STANDARD DEPARTURE CHART - INSTRUMENT

RJNH / HAMAMATSU

INSTRUMENT APPROACH CHART

SAGRA FIVE DEPARTURE

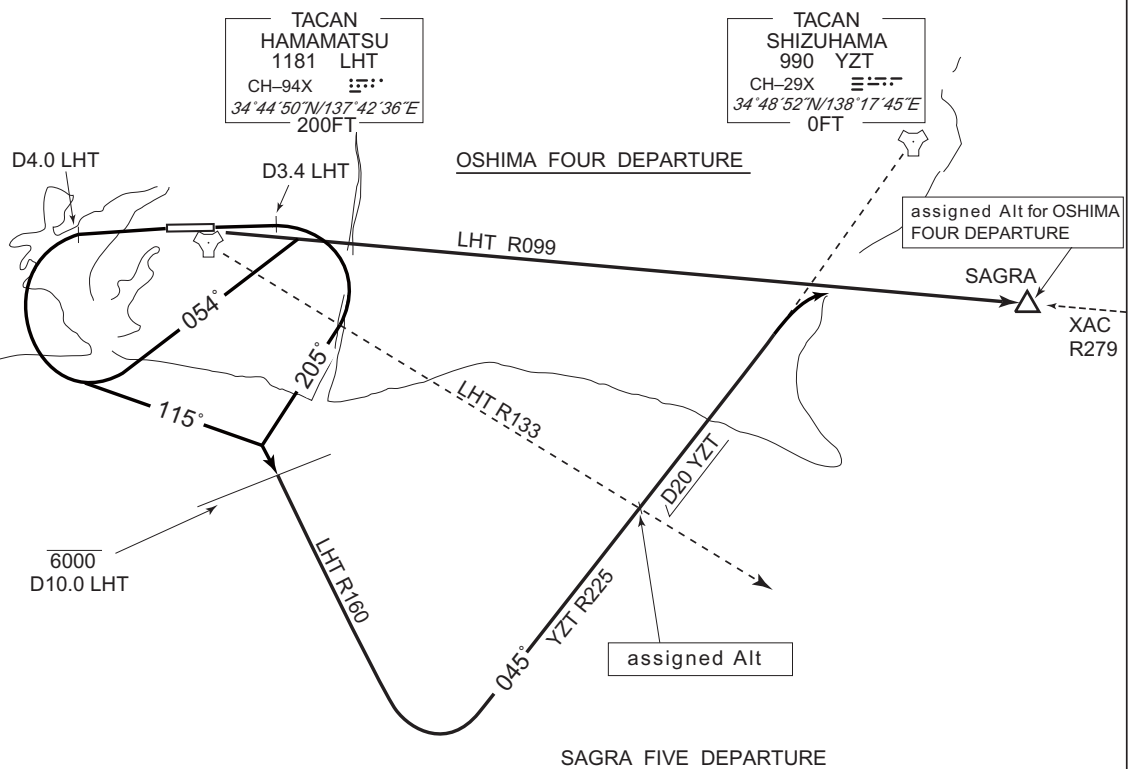
CHANGE : PROC name, PROC course(SAGRA FIVE DEPARTURE, OSHIMA FOUR DEPARTURE). Note deleted(SAGRA FIVE DEPARTURE, OSHIMA FOUR DEPARTURE).

ATSUMI FIVE DEPARTURE

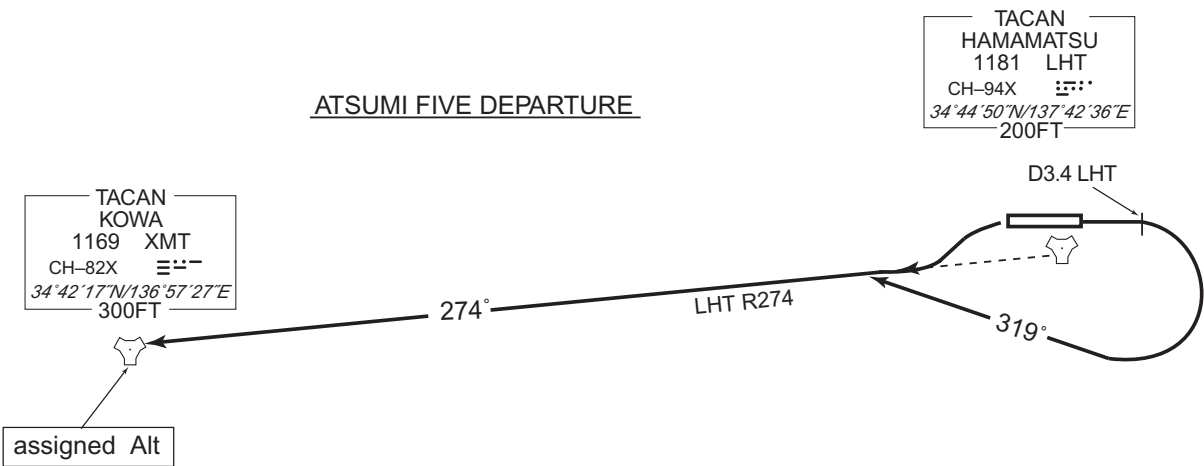
CHANGE : PROC renamed. PROC course. Note deleted.

HAMAMATSU REVERSAL THREE DEPARTURE

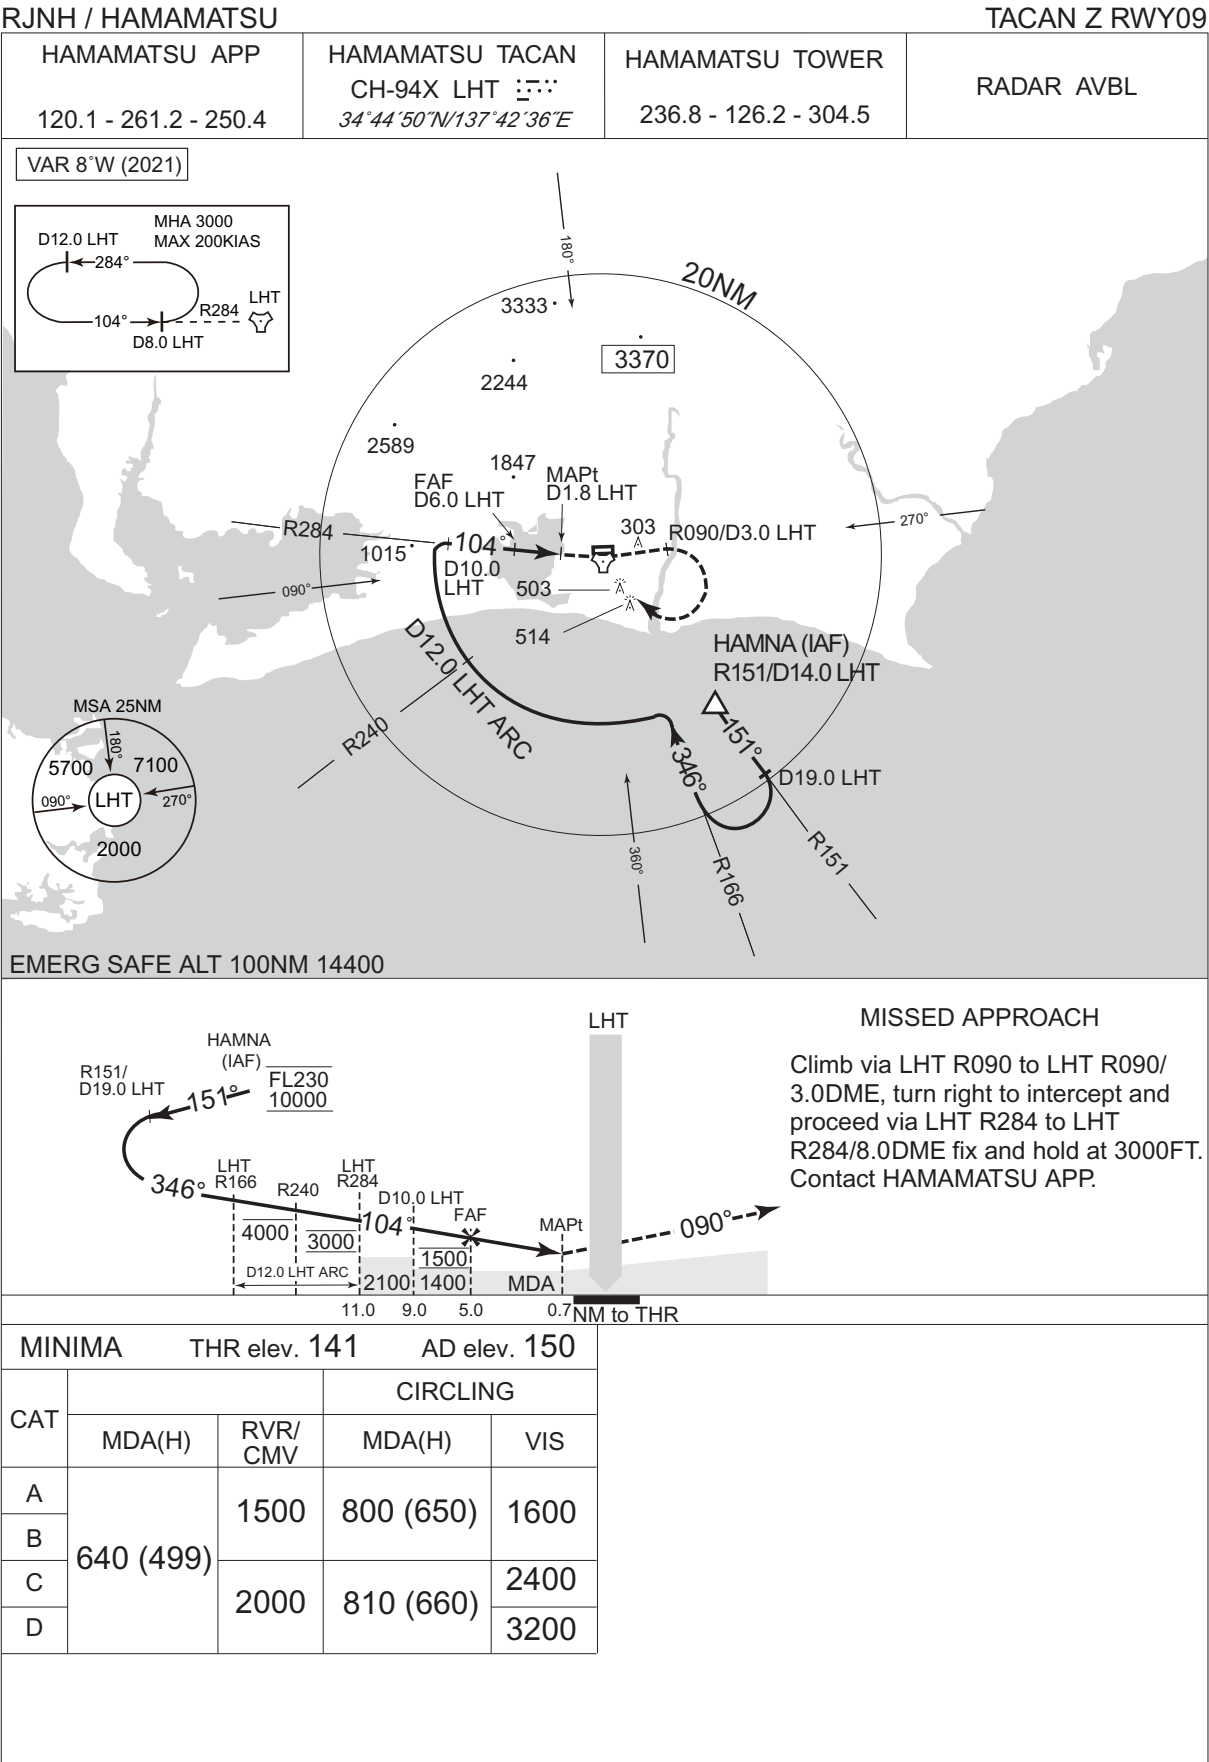
CHANGE : PROC renamed. PROC course. Note deleted.

TACAN Y RWY09

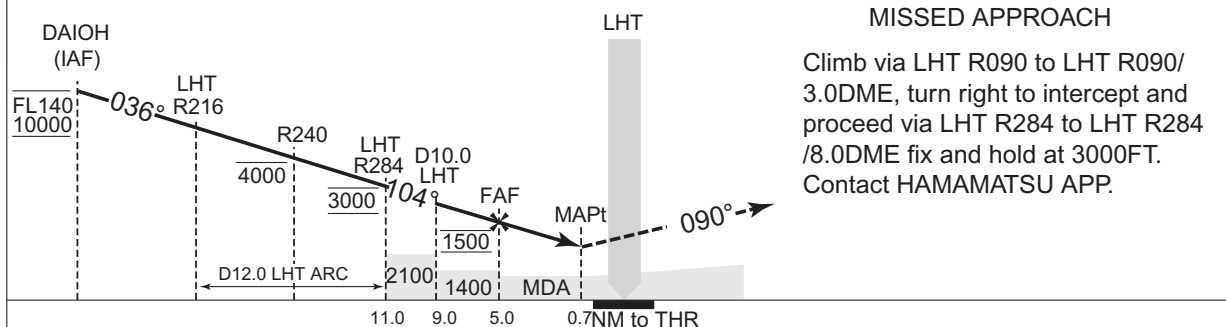
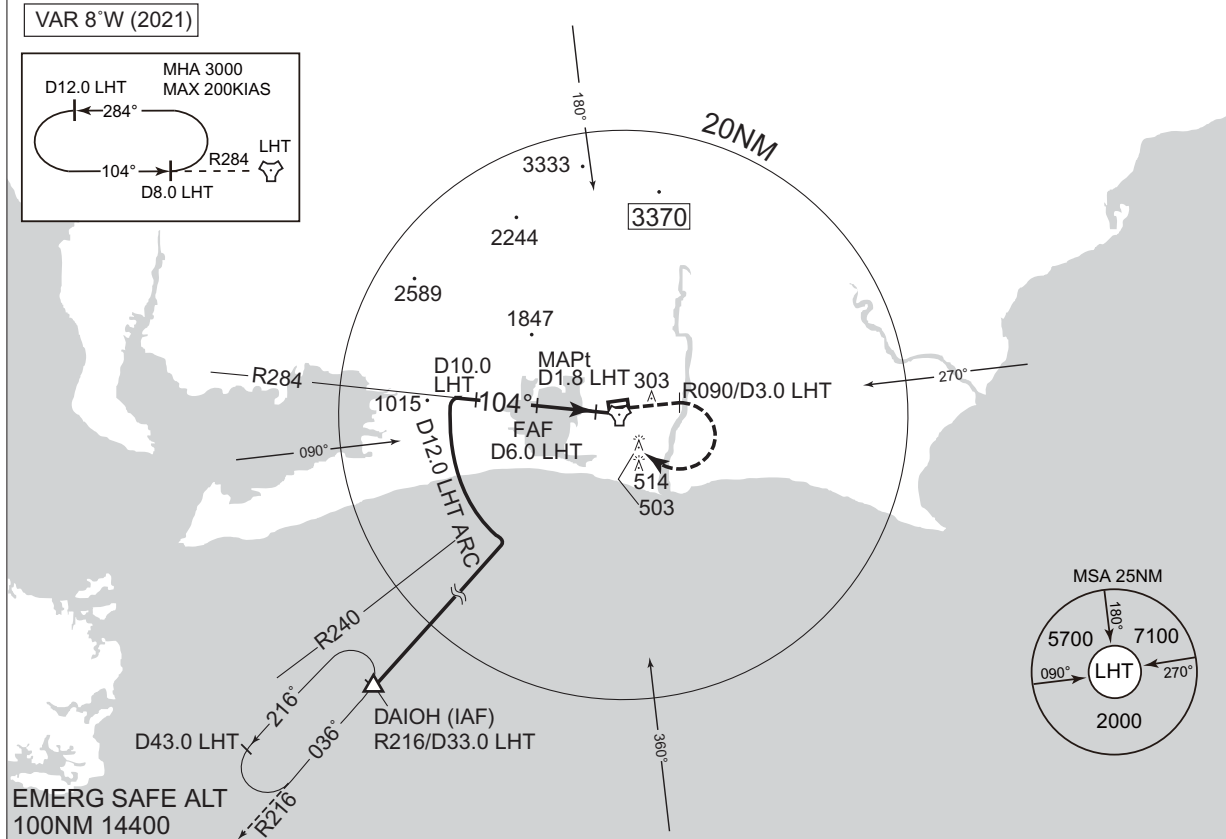
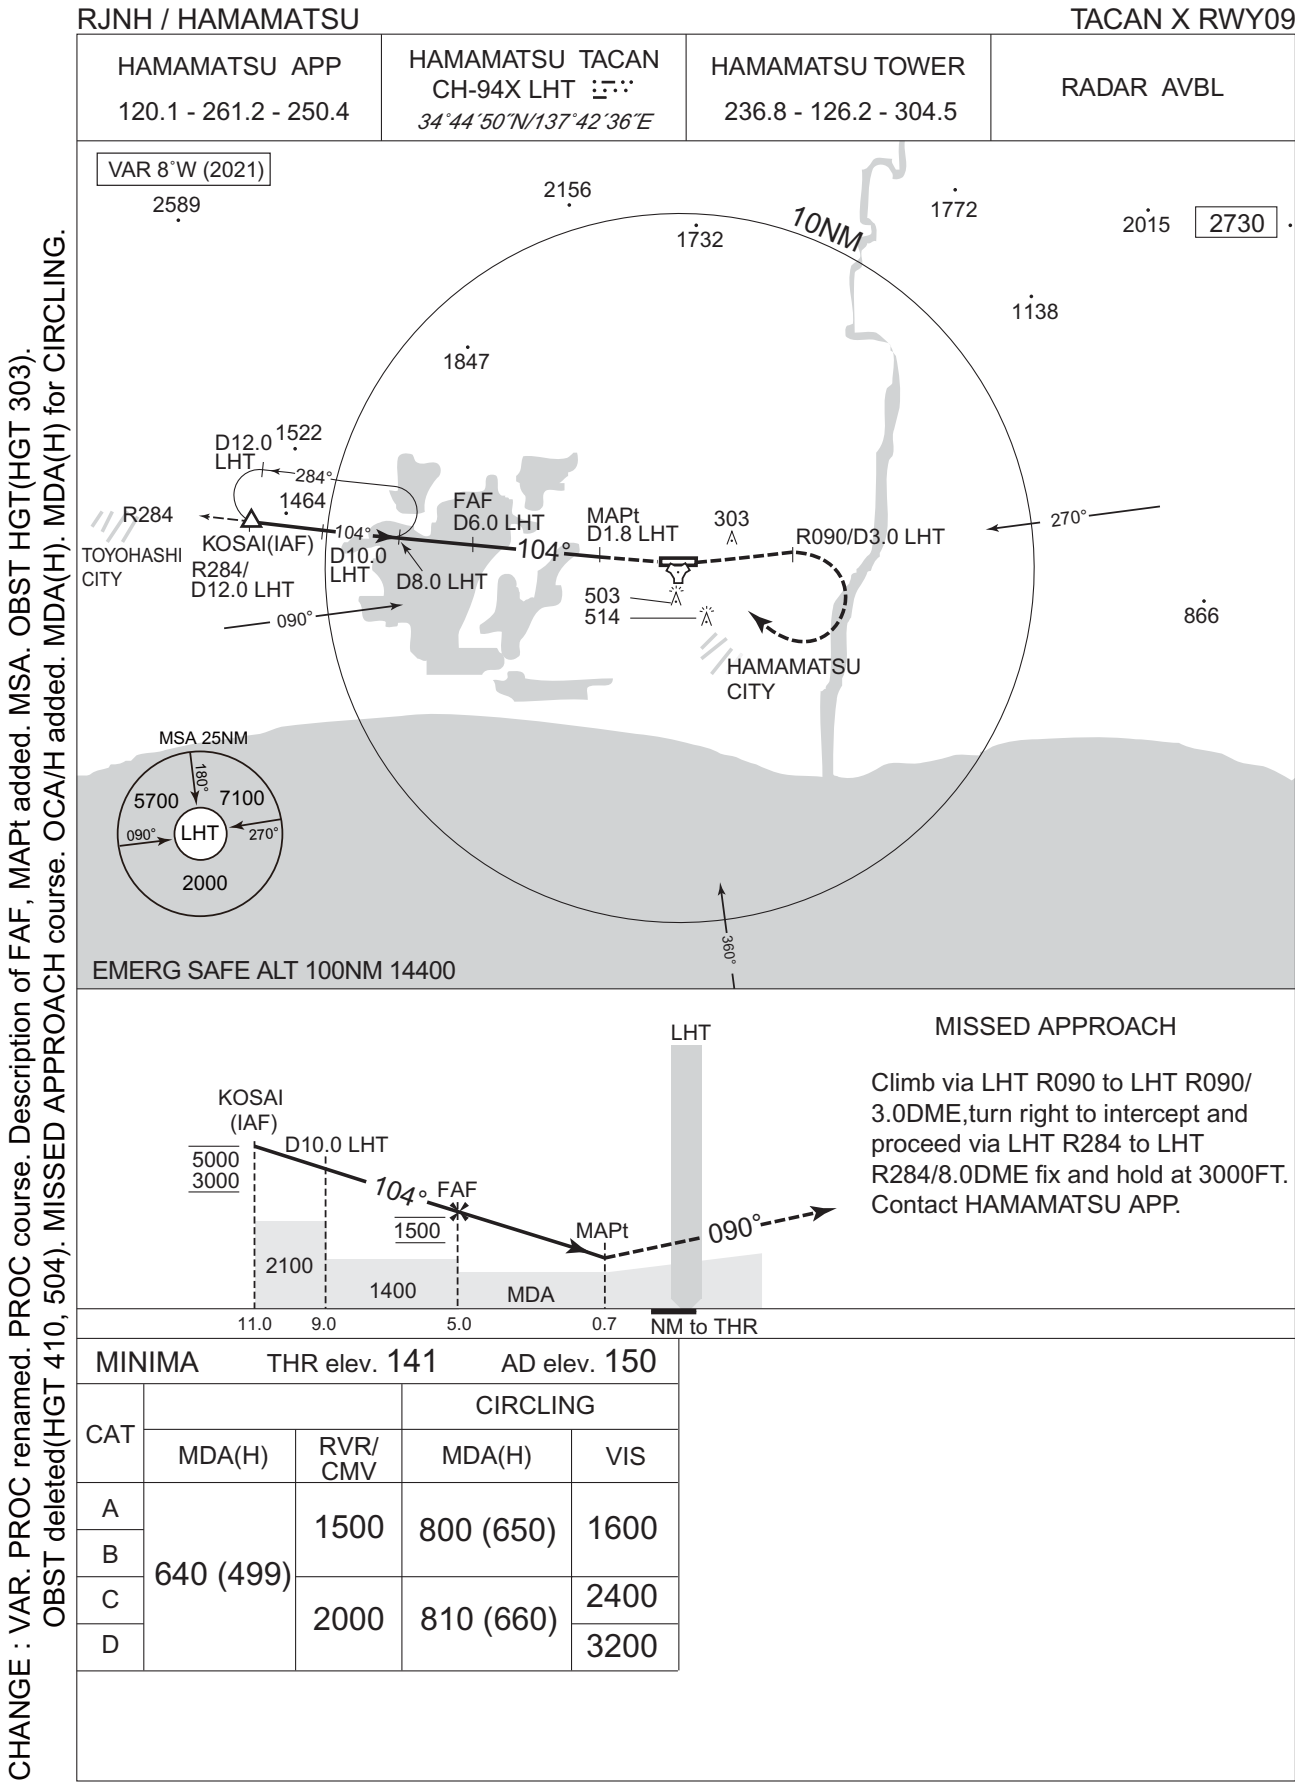
CHANGE : VAR. PROC renamed. PROC course. Description of FAF, MAPt added. MSA. HLDG pattern added. OBST added(HGT 303).
OBST deleted(HGT 410, 504). MISSED APPROACH course. OCA/H added. MDA(H). MDA(H) for CIRCLING.

TACAN Z RWY27

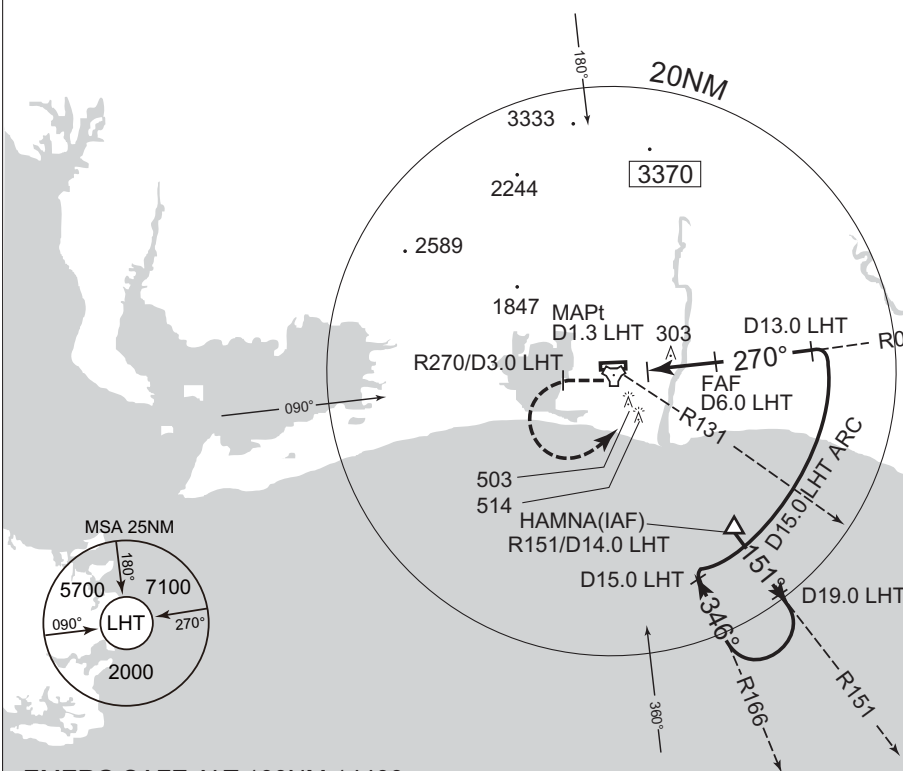
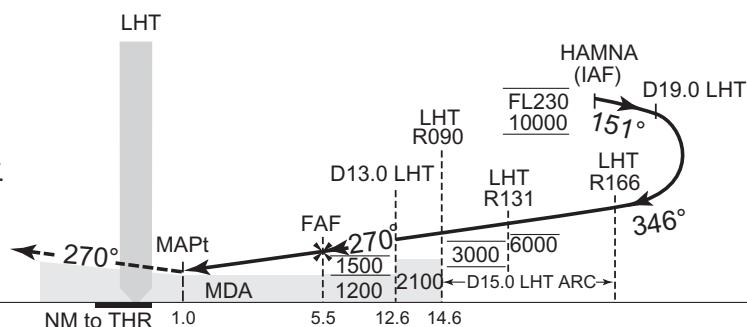
CHANGE : VAR. PROC renamed. PROC course. Description of FAF, MAPt added. OBST added(HGT 303).
OBST deleted(HGT 410, 504). MISSED APPROACH course. ALT restriction(LHT R090). OCA/H added. MDA(H). MDA(H) for CIRCLING.

TACAN Y RWY27

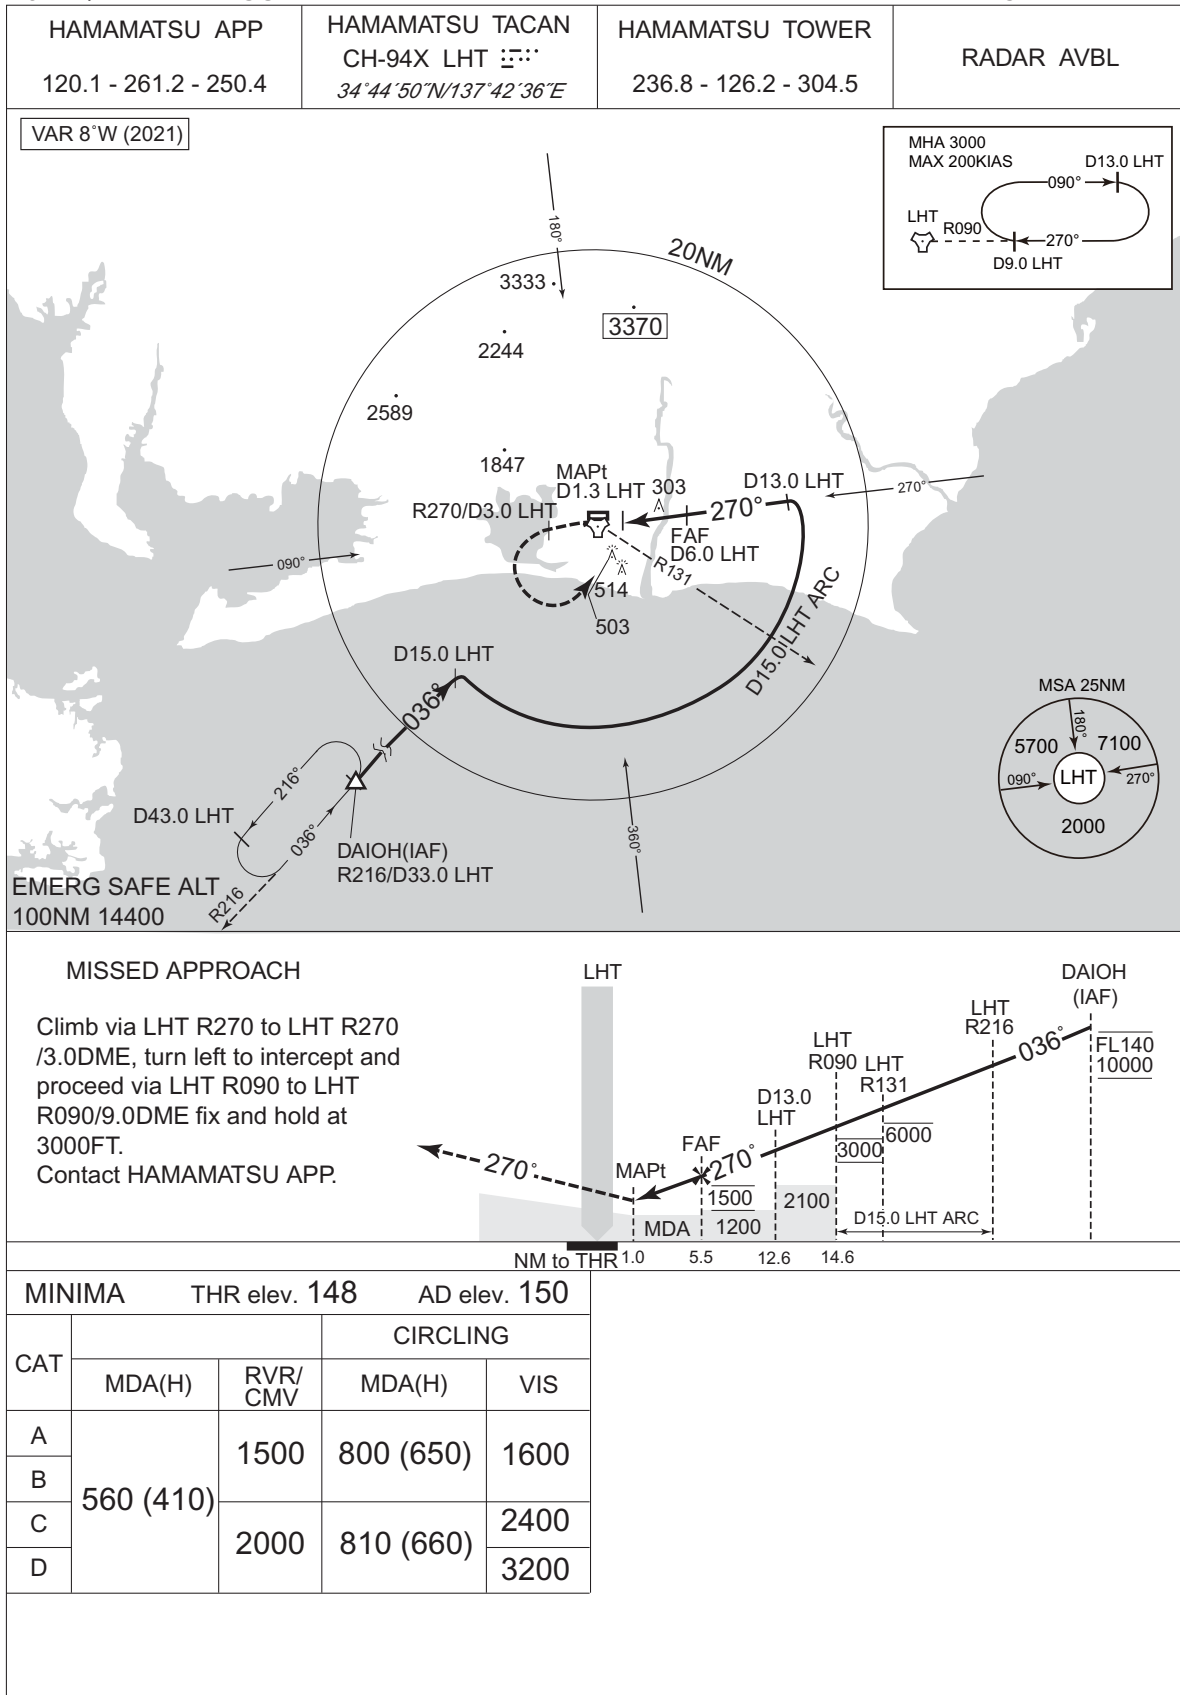
CHANGE : VAR. PROC renamed. PROC course. Description of FAF, MAPt added. MSA. HLDG pattern added. OBST added(HGT 303). OBST deleted(HGT 410, 504). MISSED APPROACH course. ALT restriction(DAIOH, LHT R090). OCA/H added. MDA(H). MDA(H) for CIRCLING.
